ONONDAGA LAKE CAPPING, DREDGING, HABITAT AND PROFUNDAL ZONE (SMU 8) FINAL DESIGN

METRO OUTFALL VICINITY DESIGN ADDENDUM

SUMMARY OF DESIGN REVISIONS

REMEDIATION AREA D & E DREDGING AND CAPPING PLAN

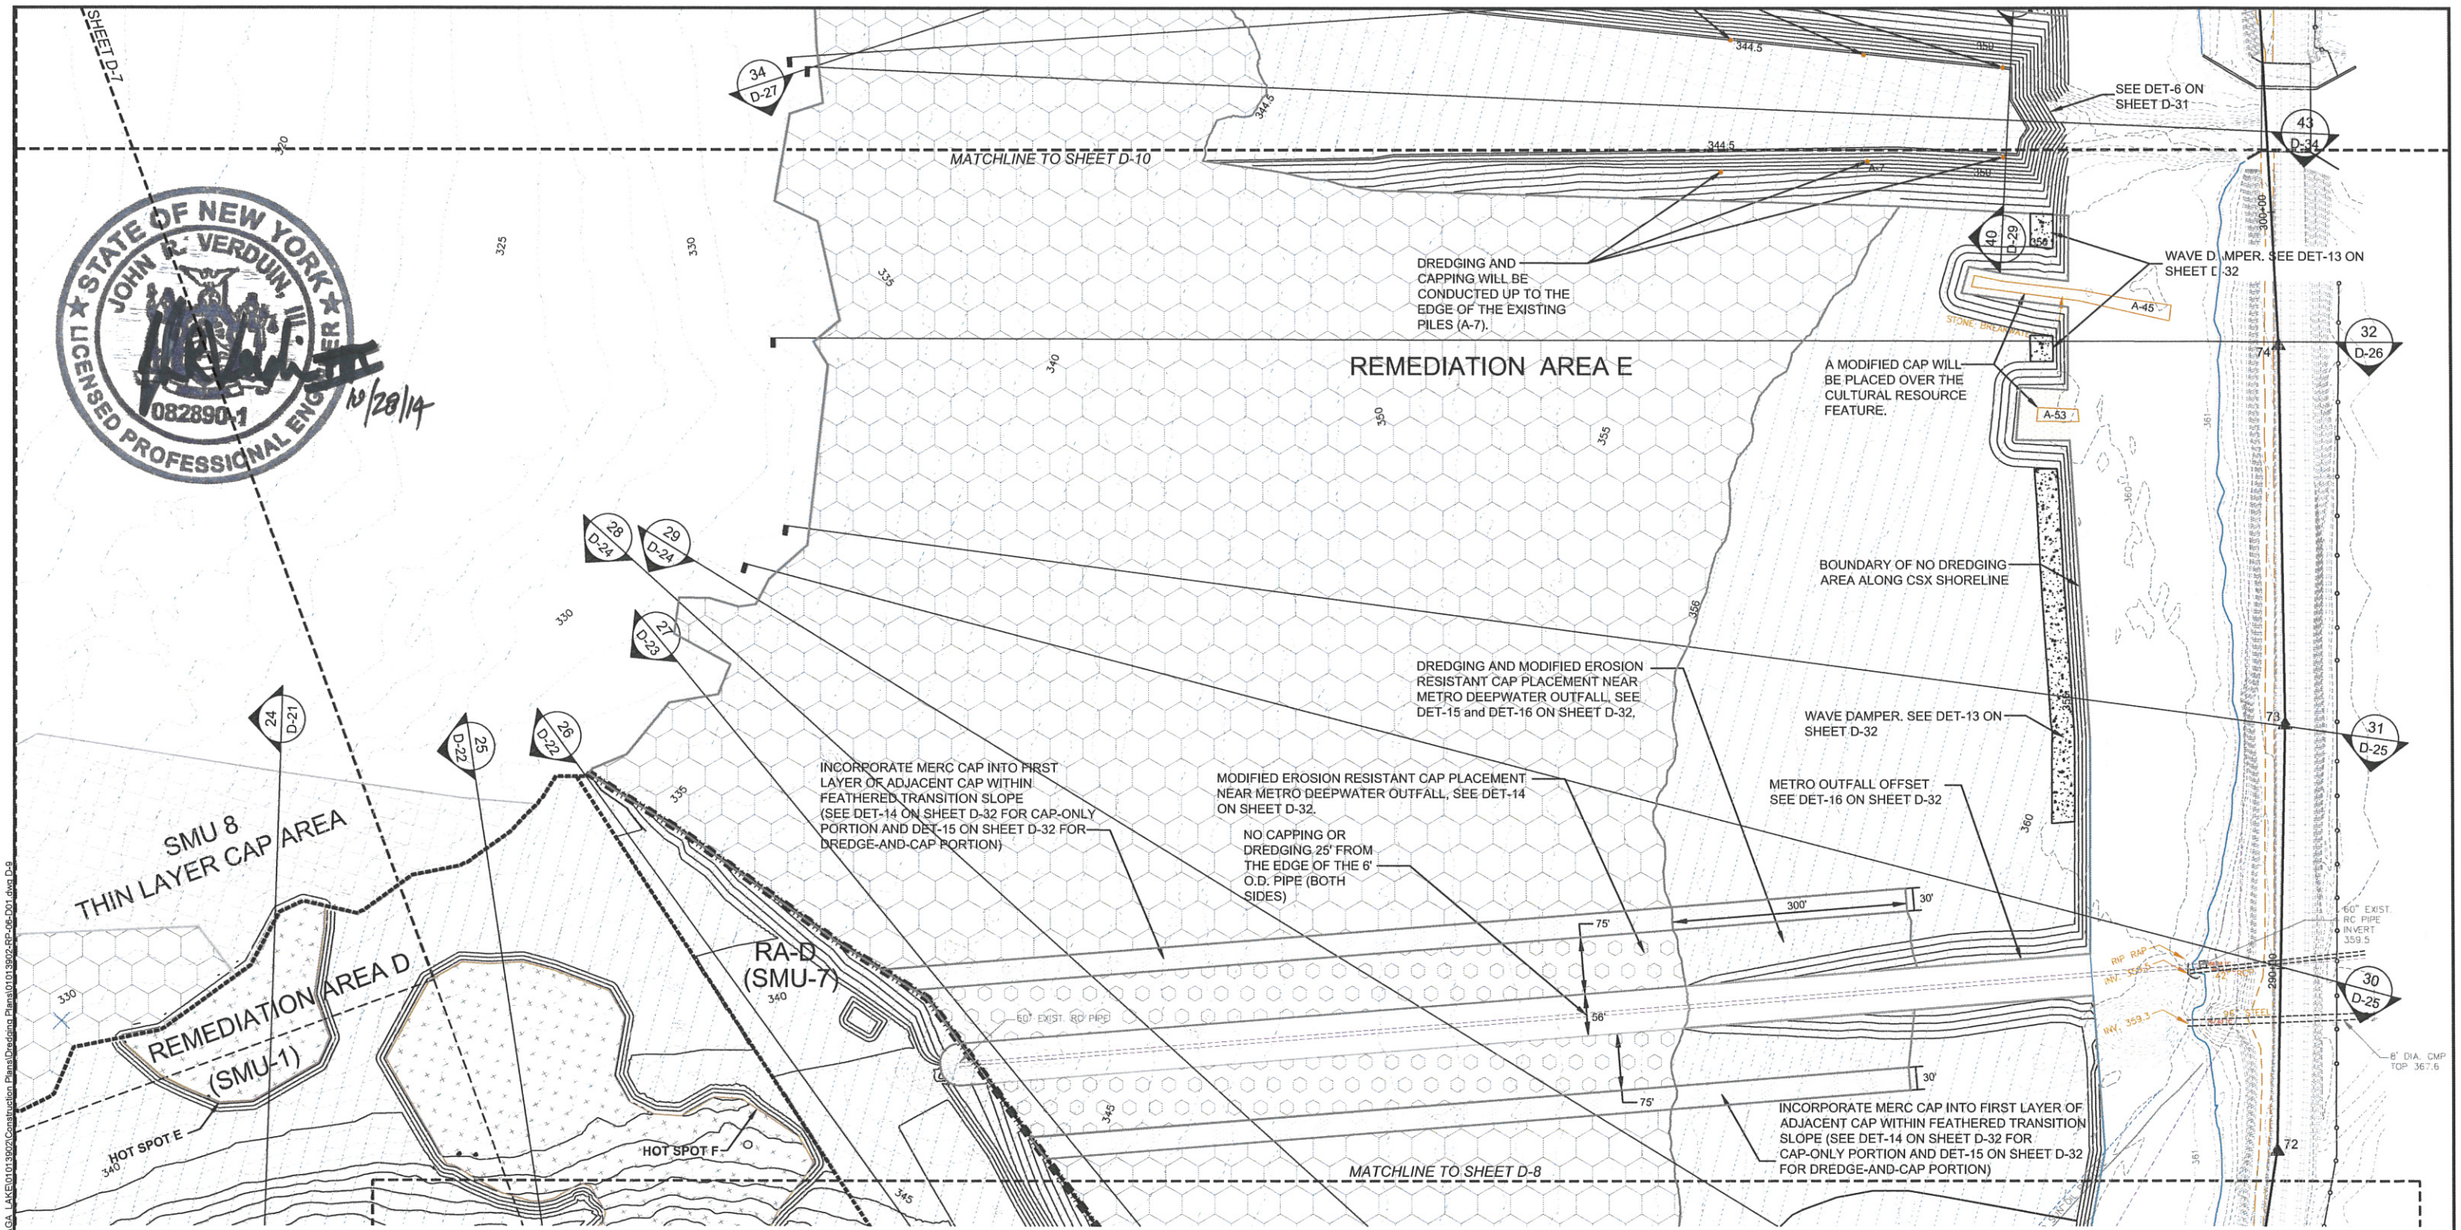
REV	DATE	BY	APP'D	DESCRIPTION
0	03/05/12	WJD	JRV	ISSUED FOR CONSTRUCTION
1	08/07/13	WJD	JRV	ADDED CULTURAL RESOURCE A13 AND 25-FT NO CAP BUFFER
2	10/23/14	WJD	JRV	REVISED REMEDIATION AREA E

- No dredging or capping within 25 ft. of the pipeline.
- A modified erosion-resistant cap in the zone between 25 ft. and 100 ft. of the pipeline in areas where there is minimal or no dredging prior to capping. This cap will consist of 6 inches of gravely sand, which is the maximum cap thickness and coarsest substrate that can be applied in this area based on cap stability considerations (Attachment 1). This will help reduce scour and resuspension of underlying sediments due to wind/wave action, but will not be coarse enough to meet the predicted erosive force of a 100-year storm event, which is the design basis for the surrounding area. Due to the reduced cap thickness, the cap surface elevation in this area will be approximately 2 ft. lower than the surrounding cap elevation, which will reduce erosive forces in this area.

The total area adjacent to the pipeline that will not be capped is approximately 1.9 acres. The area where the modified erosion-resistant cap will be places is approximately 4.3 acres. The revised capping plan is presented in the attached revised design sheets. Monitoring, maintenance, contingency actions and institutional controls will be addressed in consultation with NYSDEC during finalization of the Onondaga Lake Operations and Maintenance Scoping Document.

REMEDIATION AREA E DREDGING AND CAPPING CROSS SECTION 27

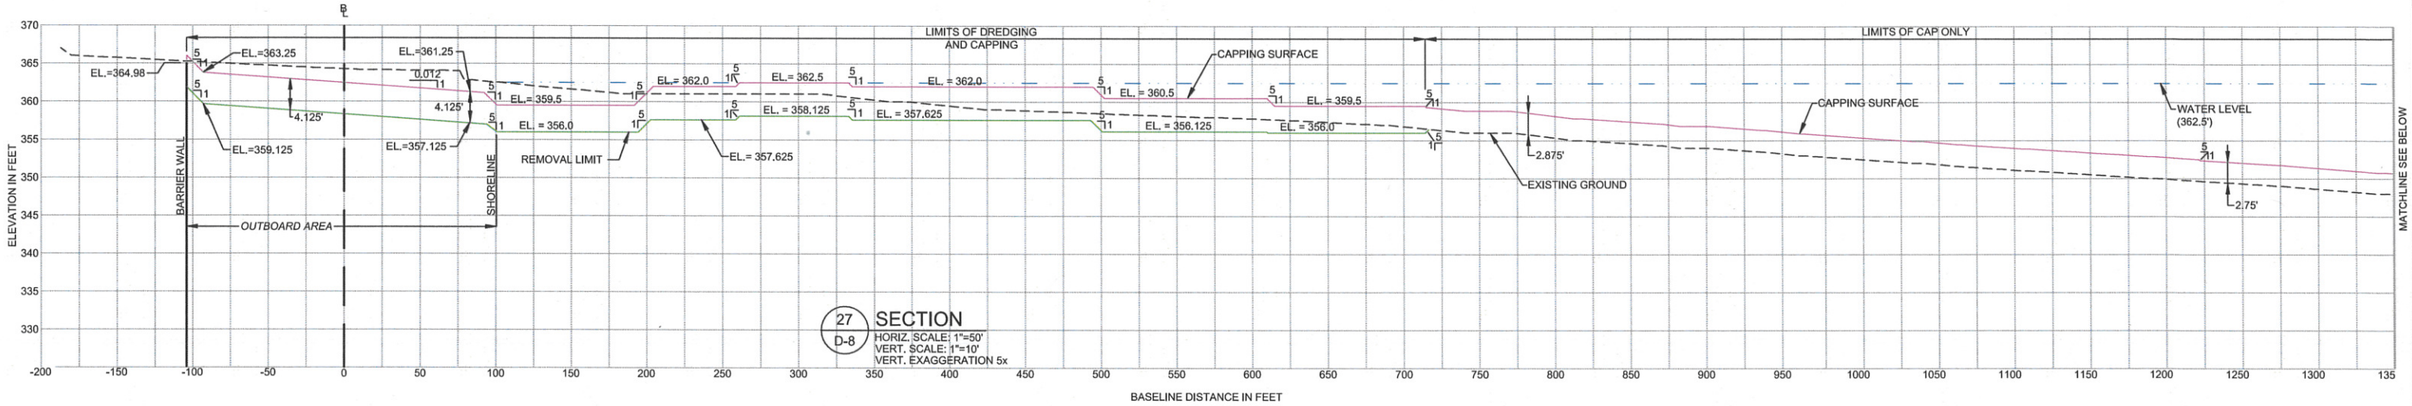
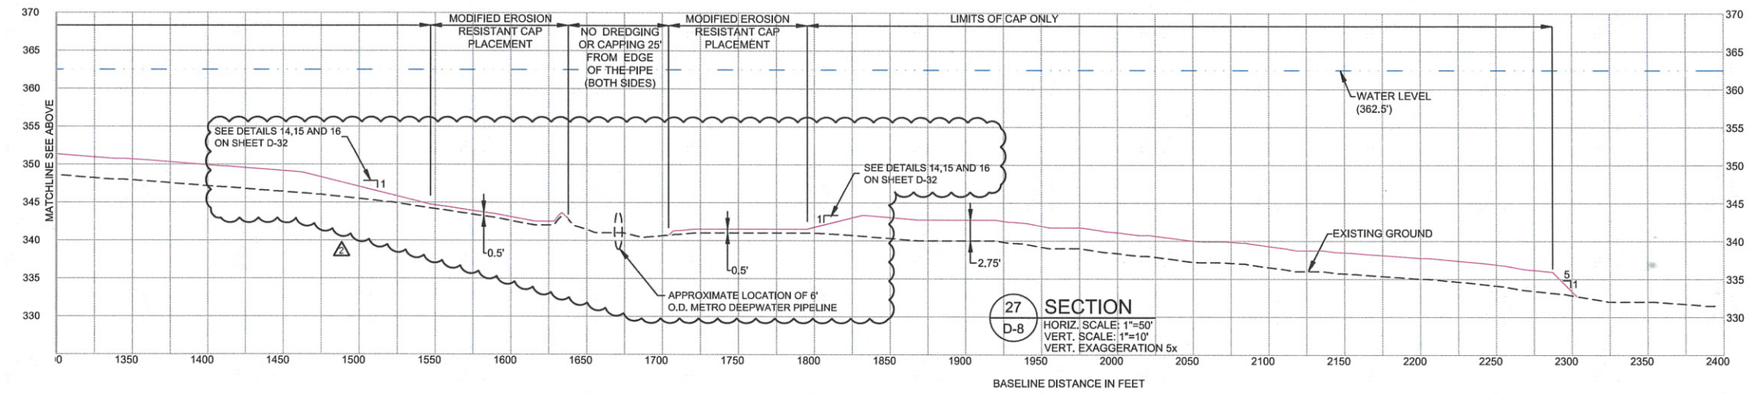
REV	DATE	BY	APP'D	DESCRIPTION
0	03/05/12	WJD	JRV	ISSUED FOR CONSTRUCTION
1	08/07/13	WJD	JRV	ADDED CULTURAL RESOURCE A13 AND 25-FT NO CAP BUFFER
2	10/23/14	WJD	JRV	REVISED REMEDIATION AREA E

REMEDIATION AREA E
DREDGING AND CAPPING CROSS SECTIONS 28 & 29

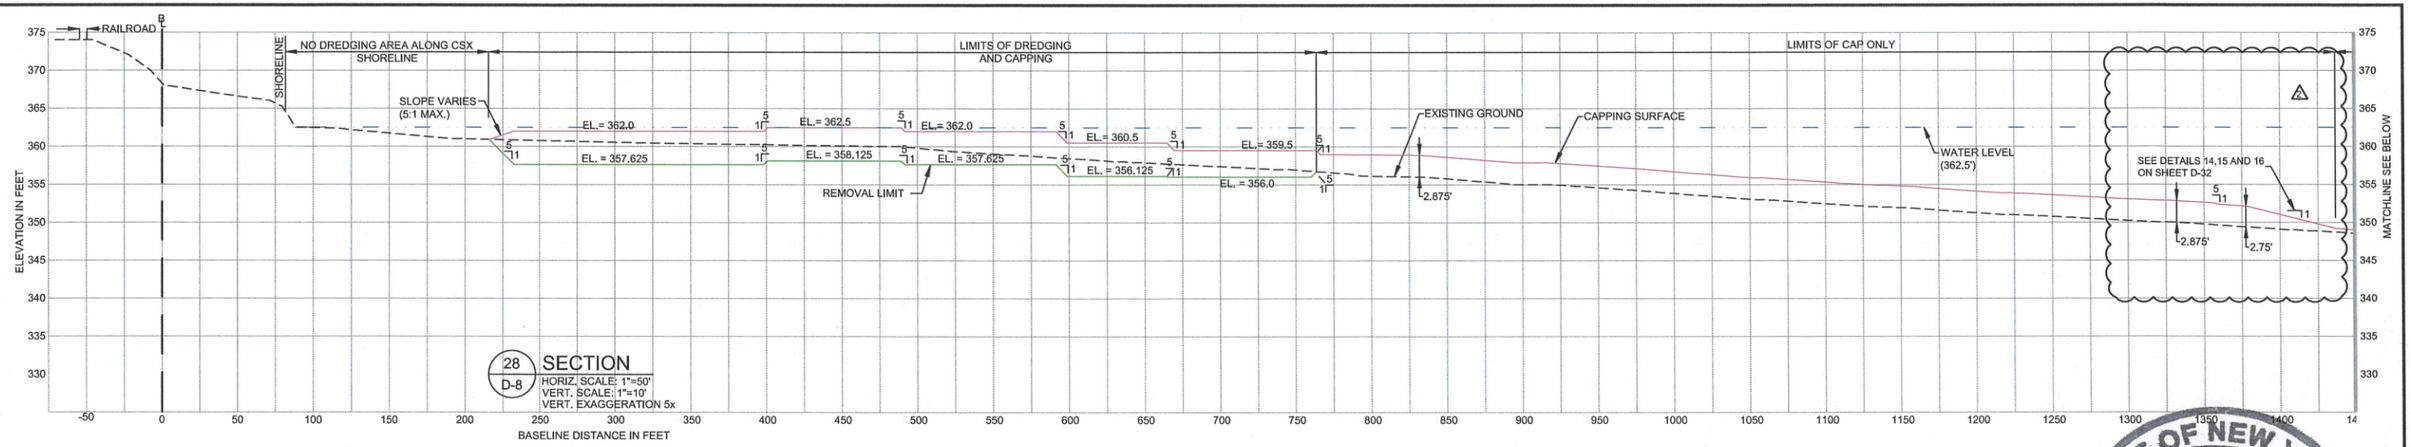
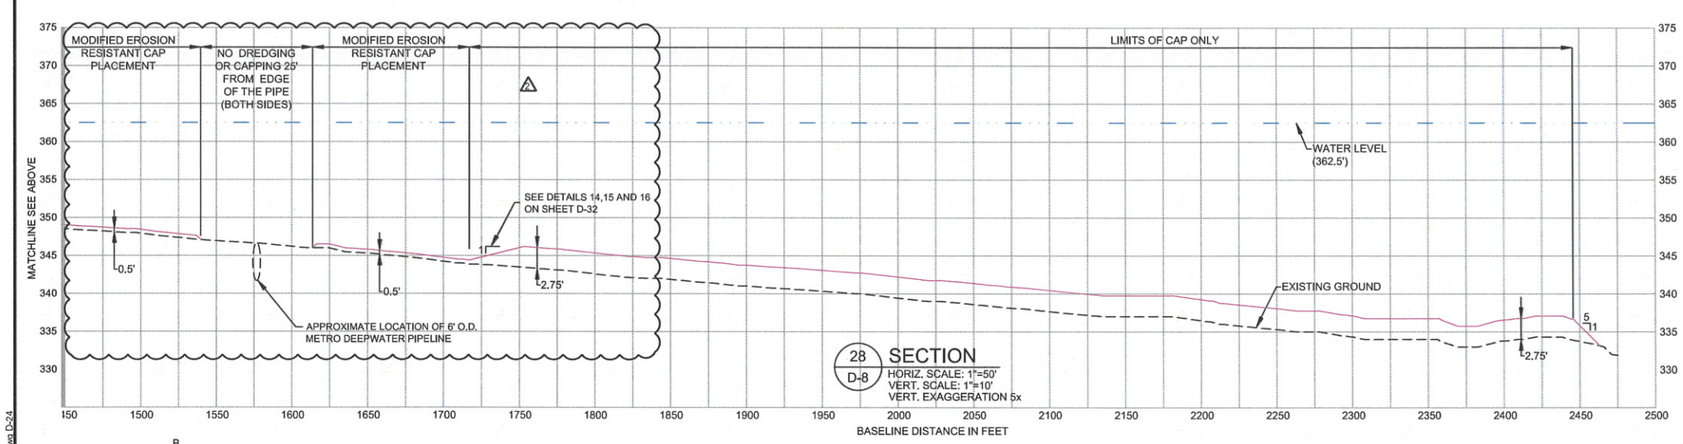
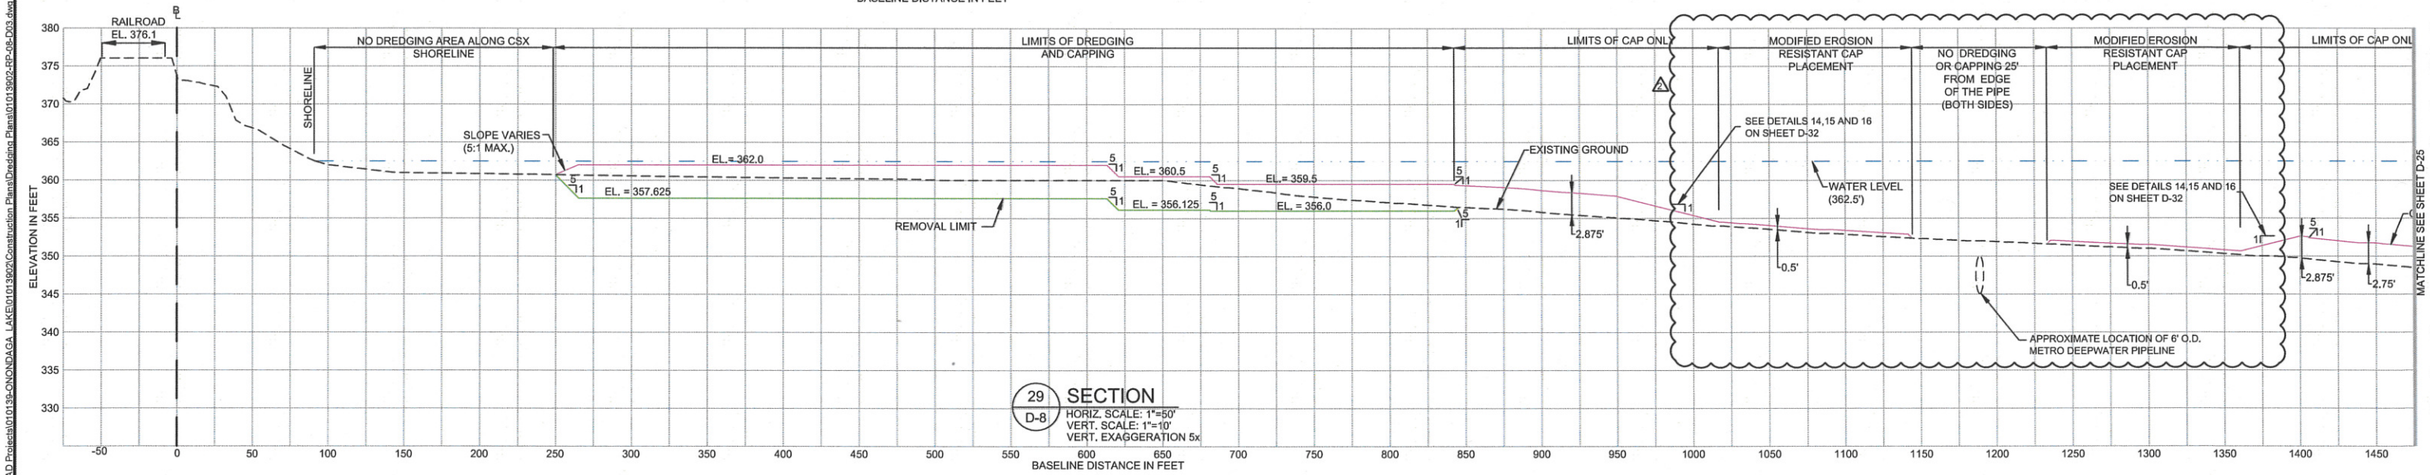
REV	DATE	BY	APP'D	DESCRIPTION
0	03/05/12	WJD	JRV	ISSUED FOR CONSTRUCTION
1	08/07/13	WJD	JRV	ADDED CULTURAL RESOURCE A13 AND 25-FT NO CAP BUFFER
2	10/23/14	WJD	JRV	REVISED REMEDIATION AREA E

DET-15
Modified Erosion Resistant Cap (Dredge & Cap Area)
(TYP.)
Not to Scale

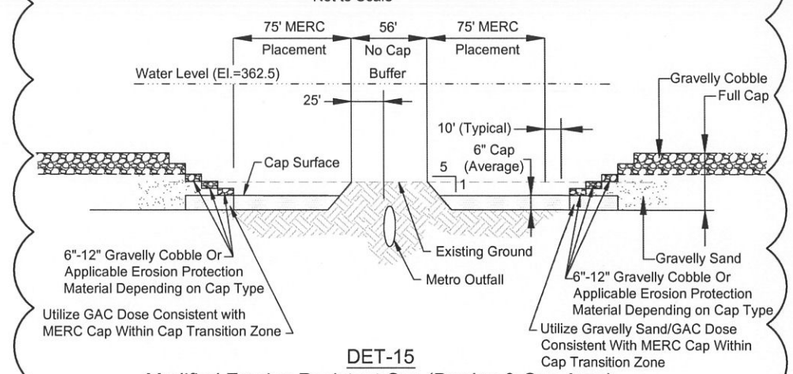
- In areas where the modified erosion-resistant cap will be placed, the cap will transition from the modified cap to the full thickness cap beyond 100 ft. of the pipeline with incremental increases in cap thickness to avoid significant differential cap loading in the transition zone.

Figure 7
Plan View of Design Offsets
Metro Deepwater Outfall Settlement Evaluation
Onondaga Lake

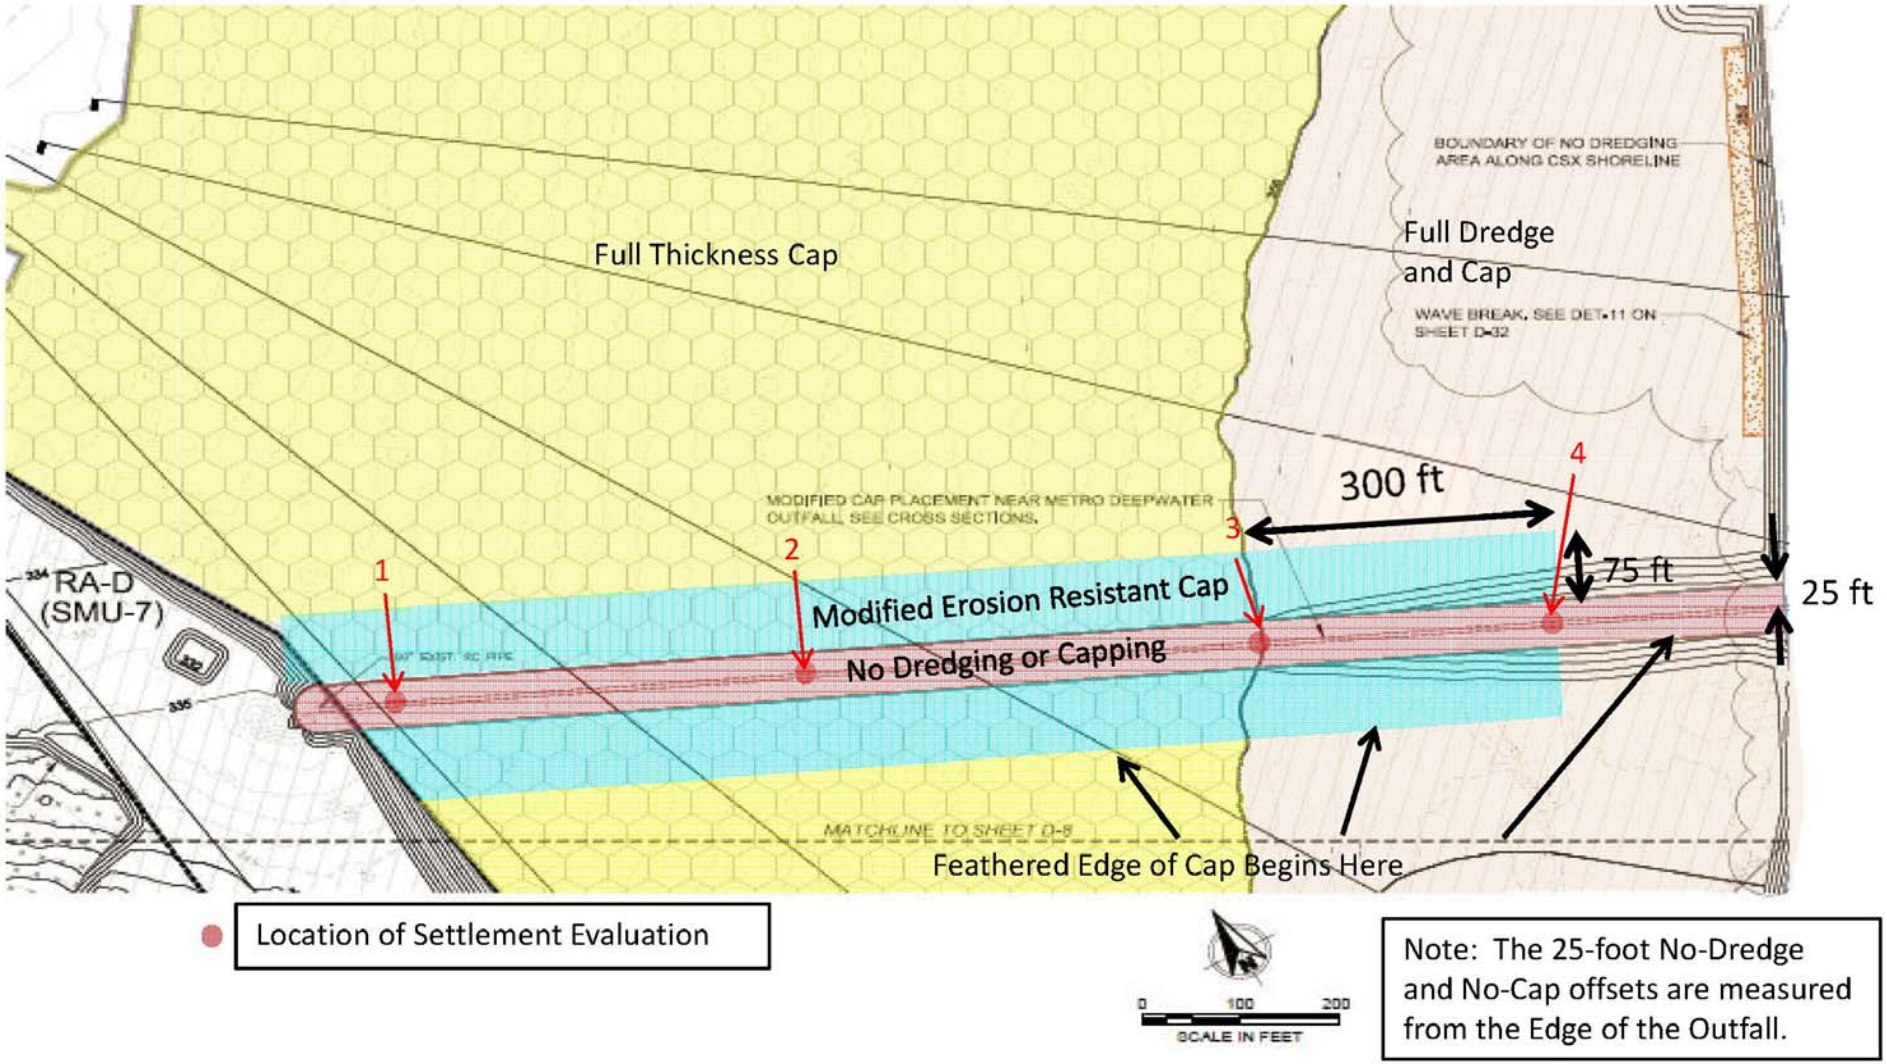
Based on the preceding differential settlement evaluations, the revised dredging and capping design in the vicinity of the Outfall includes the following components (Figure 7):

- A 25-foot No-Dredge and No-Cap offset will be incorporated for the entire length of the Outfall for both sides. This offset is measured from the edge of the Outfall.

Including the width of the Outfall (6-foot diameter), this creates a 56-foot-wide No-Dredge and No-Cap area perpendicular to the alignment of the Outfall. Additional offsets are discussed below.

- A Modified Erosion Resistant Cap (MERC) will be placed at a horizontal distance of 25 feet to 100 feet from the edge of the Outfall along most of the length of the Outfall (Figure 7).
- Where a MERC is incorporated, transition to a full thickness cap will begin at a distance of 100 feet from the edge of the Outfall, and include a gradual buildup of the cap layers (referred to as "feathered edges"), consistent with the recommended capping approach for Remediation Area E.
- In the dredge-and-cap area nearshore, dredging will initiate at a slope of 5 horizontal to 1 vertical and will continue to the required dredge elevation. Dredging will initiate at a distance of 25 feet from the edge of the Outfall.
